RPA STAFF RECOMMENDATION

Subdivision Name:	Meadow Stream Subdivision Phase 6, Lots 248 thru 346 Request for Extension of Approval Final Plat	Review Meeting Date: 12-08-14
Applicant Request:	Extension of Final Plat Approval	
Property Location:	Trout Lily Drive	
Property Owner:	McDaniel and Son Construction	
Applicant:	MAP Engineers	
Total Acreage:	82 Acres	
Proposed Density:	1.2 dwelling units per acre	
Tax Map Number:	113-095	
Zoning:	R-1 Residential District	
Staff Recommendation:	APPROVE extension of final plat approval for one year with expiration date of December 08, 2015

MEADOW STREAM SUBDIVISION PHASE VI
FOR:
McDANIEL & SON CONSTRUCTION
4033 SOUTH ACCESS ROAD
CHATTANOOGA, TN 37406

MASTER SITE PLAN

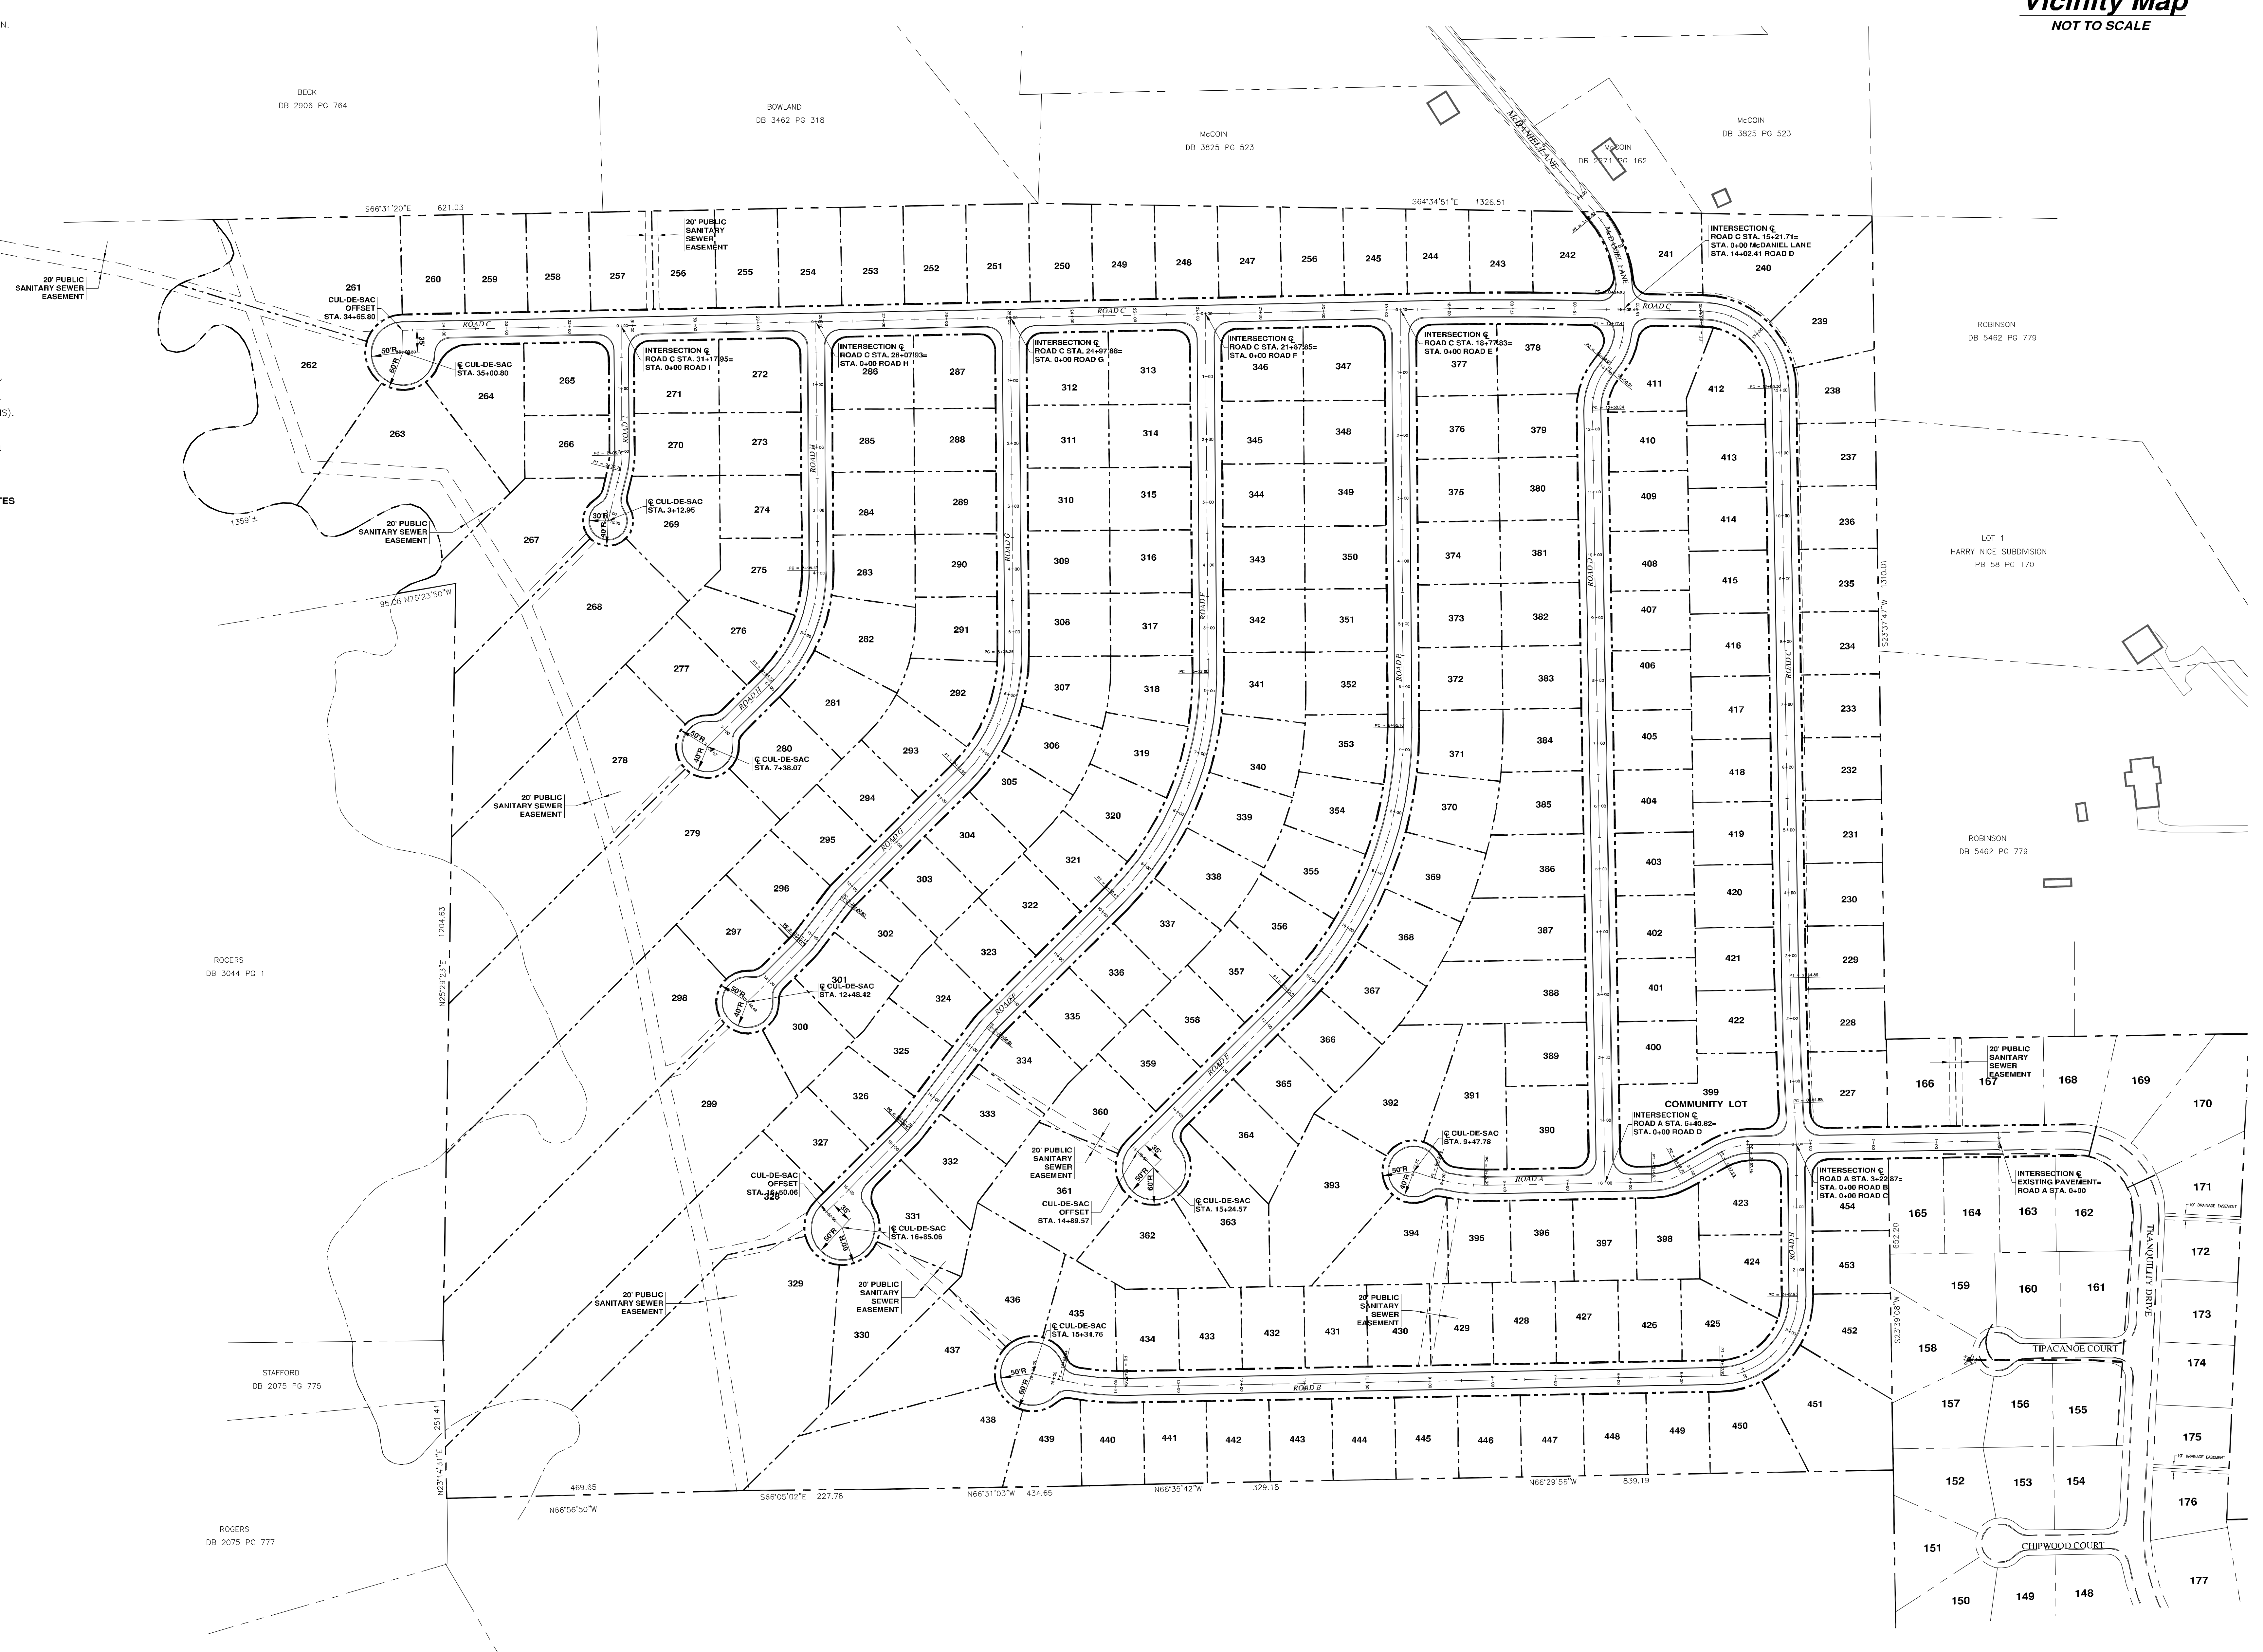
1. Show street addresses for each lot. Addresses will be assigned after the Chattanooga-Hamilton County Regional Planning Commission has formally approved the final subdivision plat.

2. Contact Hamilton County GIS for proposed street names.
3. Prior to Hamilton County GIS signing the final plat please submit a geo-referenced CAD drawing used to create this subdivision plat. If GIS doesn't receive a copy of the geo-referenced CAD drawing file GIS will not sign the final plat.
4. Questions concerning Hamilton County GIS comments and notes please contact GIS at (423) 209-7760.
